## ANNEX C

### SNODLAND CHARACTER AREA APPRAISAL SPD – RESPONSE TO CONSULTATION

Ref **A2.1**  
 Title **Holborough Road**  
 Snodland Character Area Appraisal

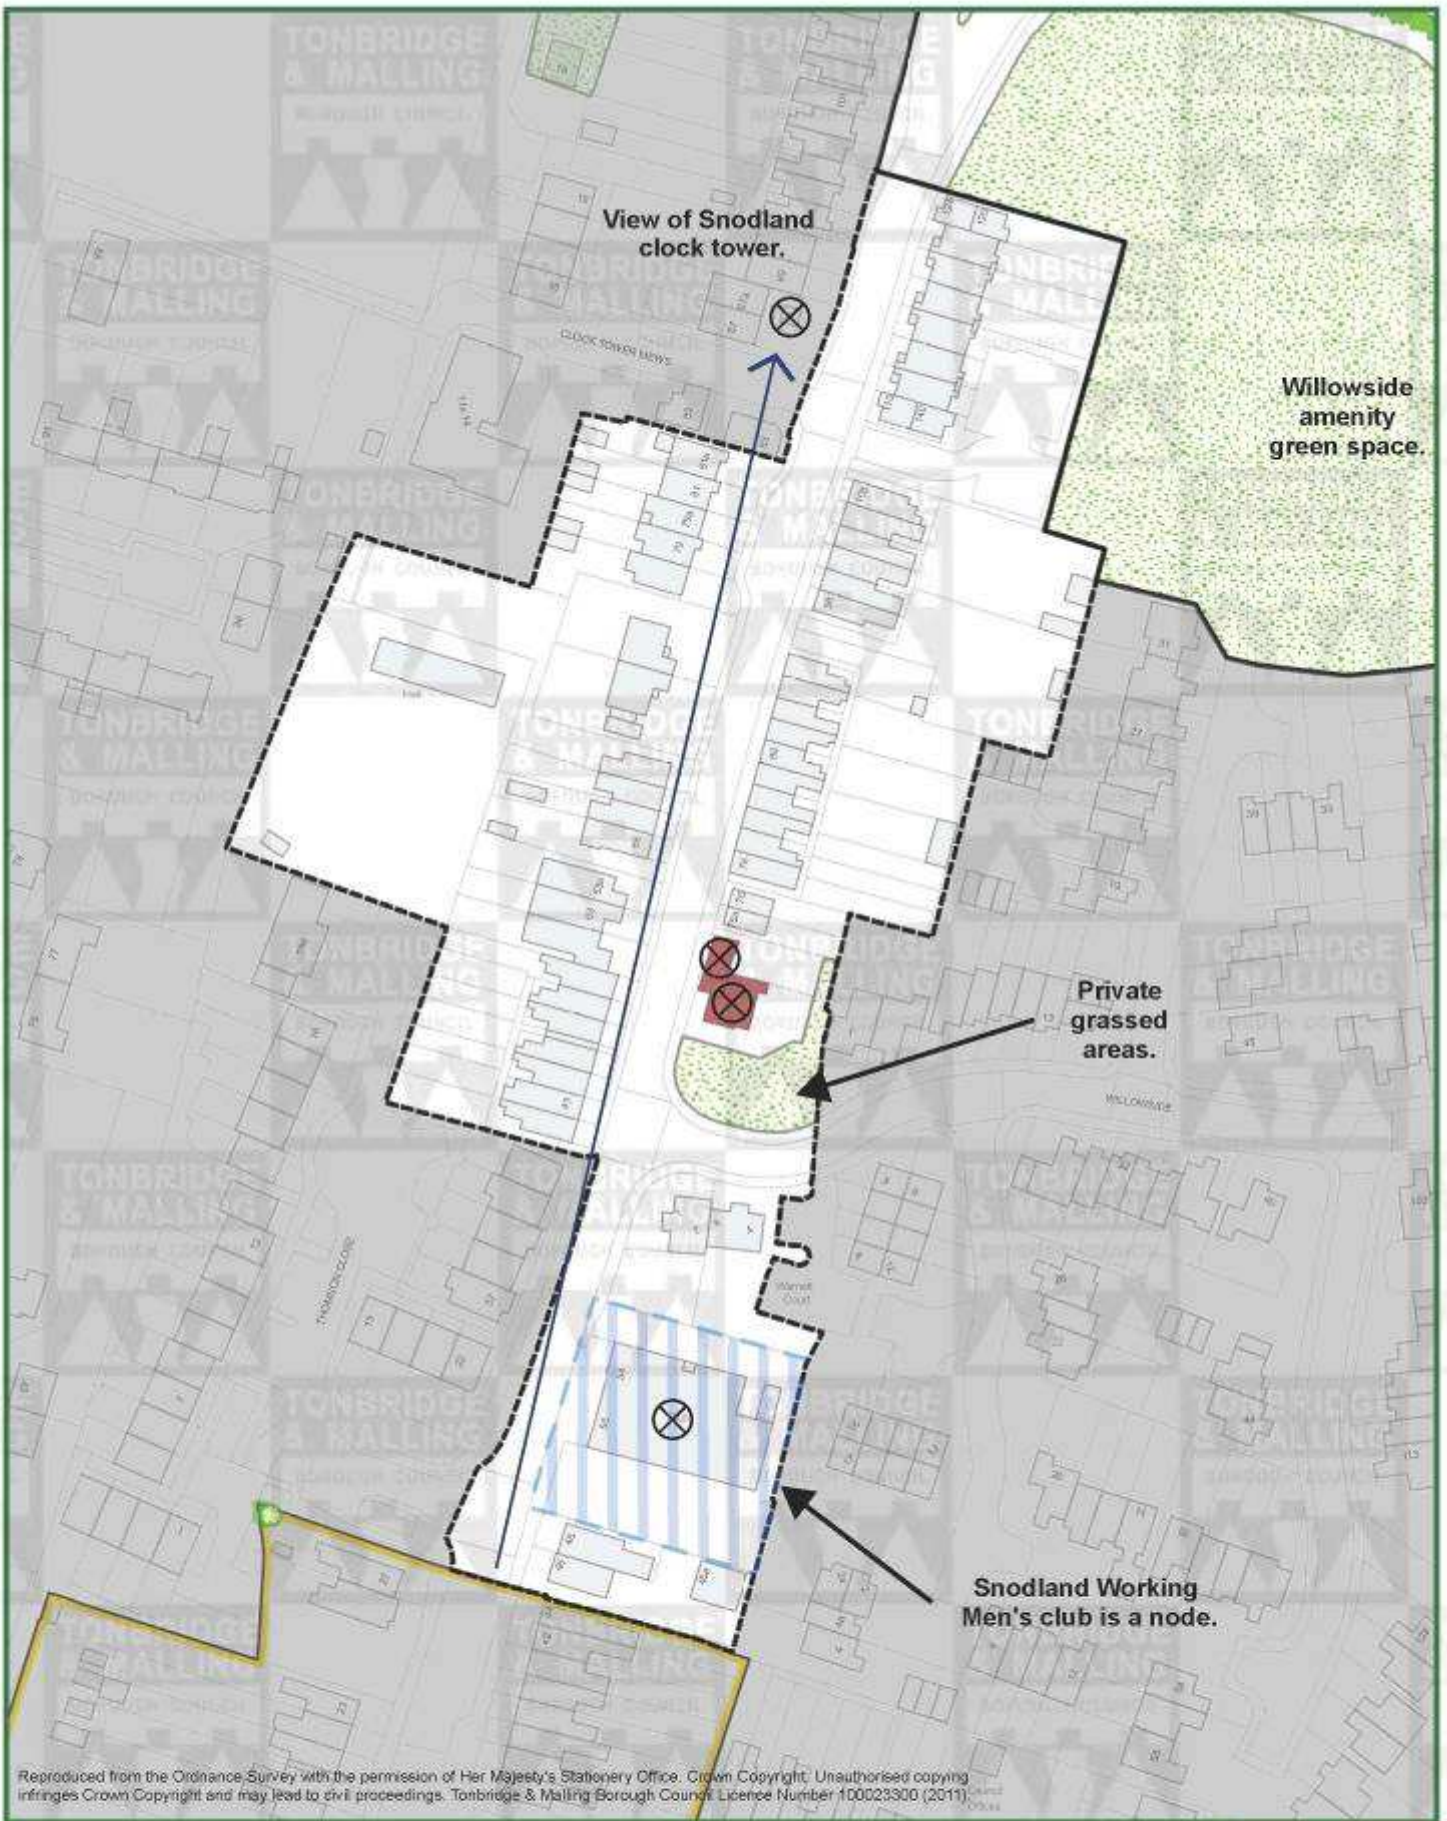
Respondent	Representation	Response
	<p><b>Area A2.1 – Holborough Road –Description</b> (p37)- The photographs do not extend to the northern end of Holborough Road so a significant length of the main road is not covered.</p>	<p><b>REVISE</b> to deal with the northern section of the road as a separate sub- area. (See <b>Appendix C1</b>)</p>
	<p><b>Area A2.1 – Holborough Road – Description</b> (p37) - The northern end of Holborough Road should be a separate sub-area. The text under the middle photograph states that there is now little uniformity of detail in Holborough Road. Do not agree:</p> <ul style="list-style-type: none"> <li>• There are distinctive short terraces of 19<sup>th</sup> century houses with narrow arched windows in groups of three with arched dormers which are not mentioned;</li> <li>• There is no mention of old yellow stock bricks with red brick banding and features to window lintels and doorways, terracotta patterned brick bands and the old traditional ragstone wall frontage;</li> <li>• Most houses at the northern end of the road are in brick and not painted render as currently described</li> <li>• The outlook onto open space is also important.</li> </ul>	<p>See above.</p>

Respondent	Representation	Response
	<p><b>Area A2.1 – Holborough Road – Negative Features</b> (p41)</p> <p>The brick wall at the far northern end of road should be removed and replaced by a hedge/trees along the edge of the bypass.</p>	<p>Noted as a negative feature worthy of enhancement in <b>Appendix C1</b></p>
<p>Vincent and Gorbing Ltd on behalf of Lafarge Cement UK</p>	<p>The document is very attractive and thorough which is a good appraisal of the character of Snodland subject to the following detailed minor points.</p>	<p>Noted</p>
	<p>There is some inconsistency in the reference to brick colours where in some cases what appear to be the same colour bricks are described in different places as yellow, orange, buff or brown.</p>	<p>This will be checked carefully and any inconsistencies addressed.</p>
	<p><b>Map 2</b> – label for Area B3 is incorrectly located within Area E7.</p>	<p><b>CORRECT Map 2</b></p>

Ref **A2.4**  
 Title **Holborough Road North**

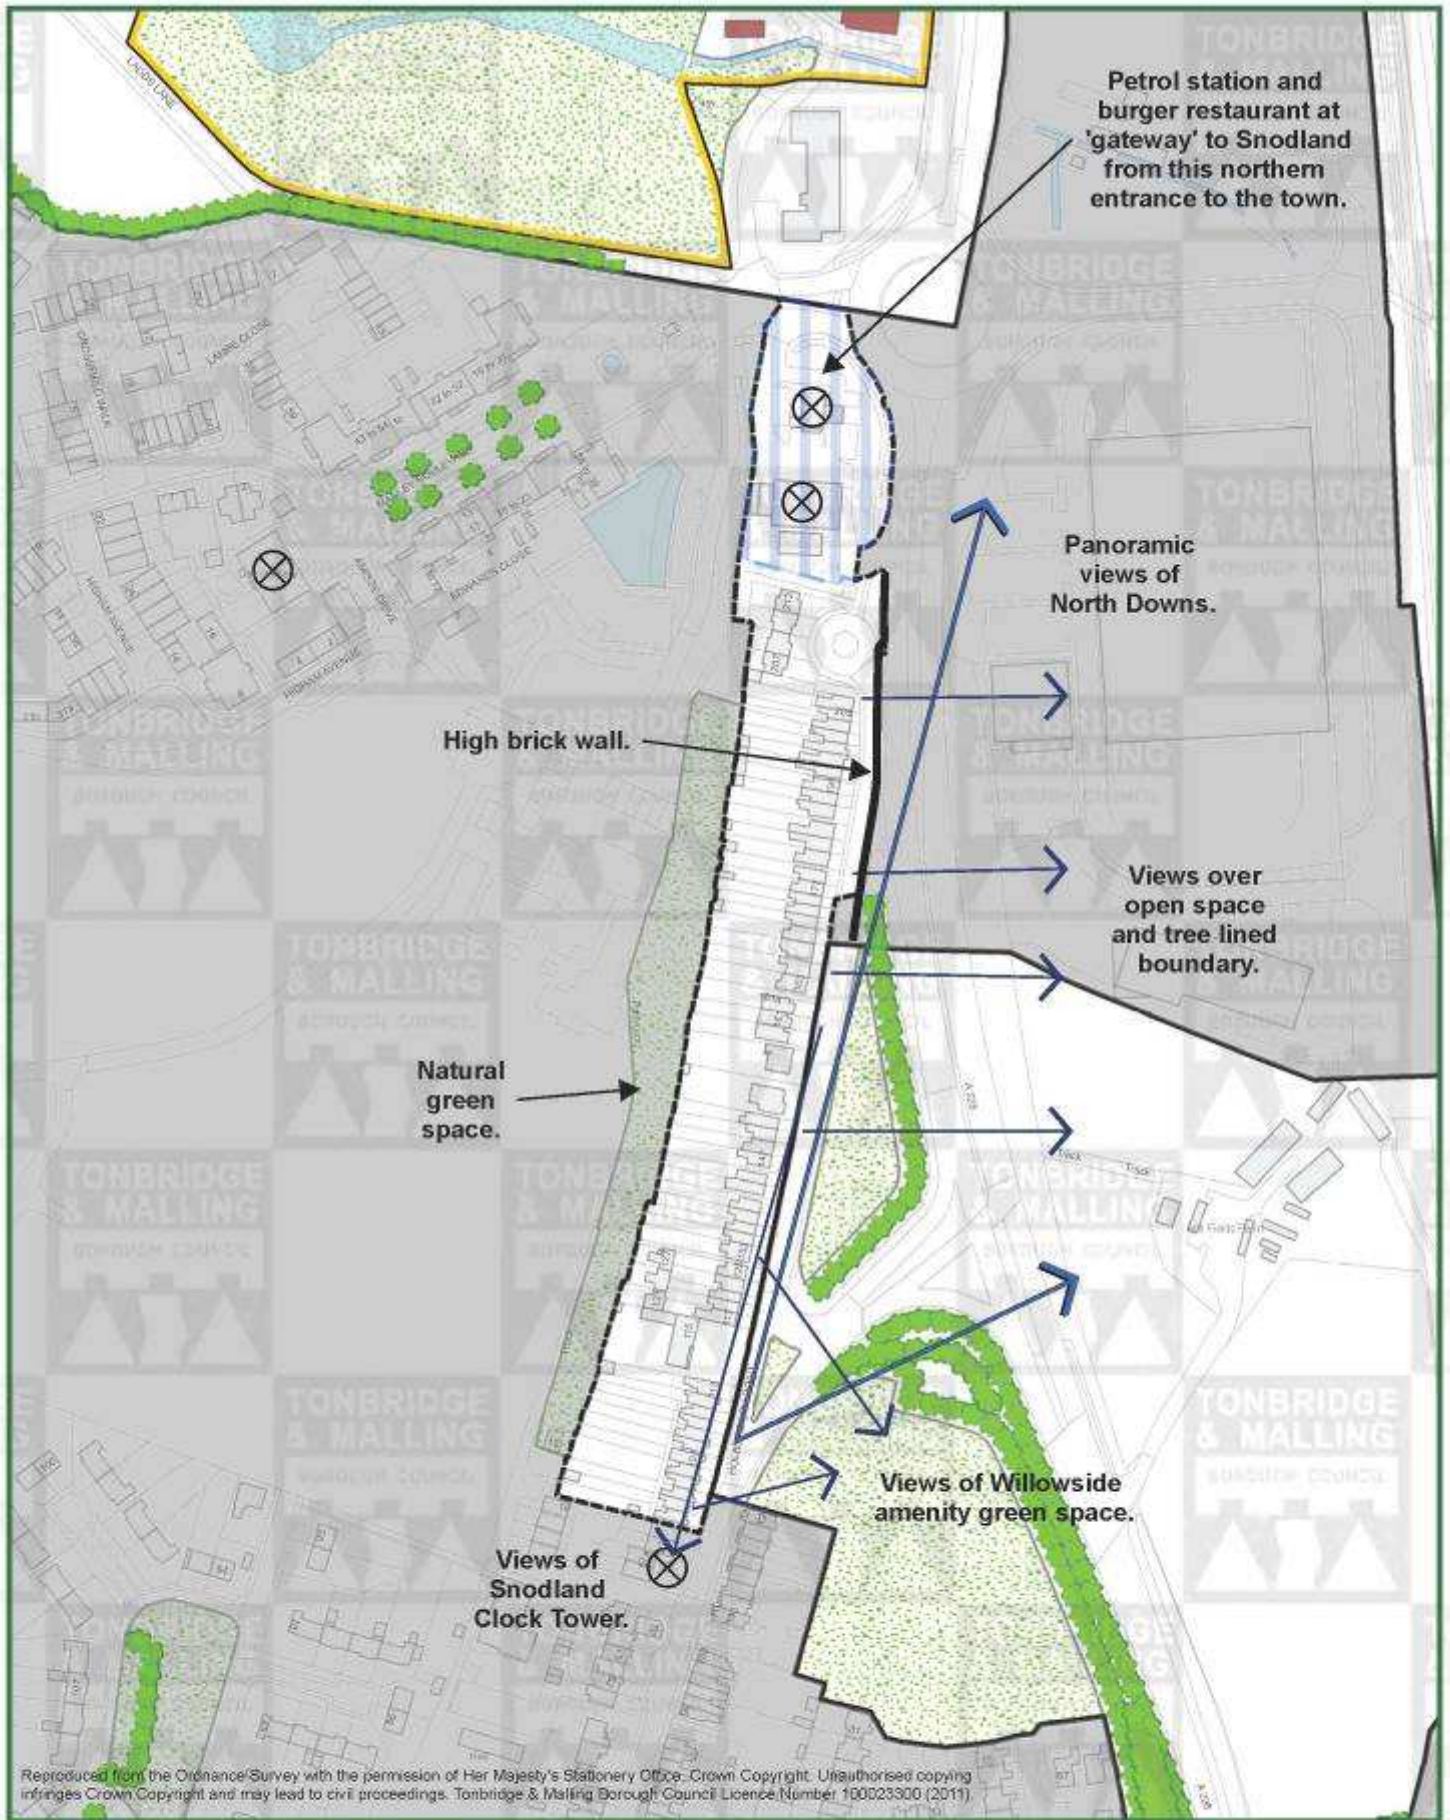
<p><b>Area A2.1 – Holborough Road – Positive Features</b> (p41):</p> <p>Need to include:</p> <ul style="list-style-type: none"> <li>• Views over open space to the tree line along the bypass;</li> <li>• No through traffic because it is a cul-de-sac;</li> <li>• Quiet despite proximity of major road;</li> <li>• 19<sup>th</sup> century cottages add interest to road frontage.</li> </ul>	<p>The new sub-area for Holborough Road North addresses these issues – see <b>Appendix C1</b></p>
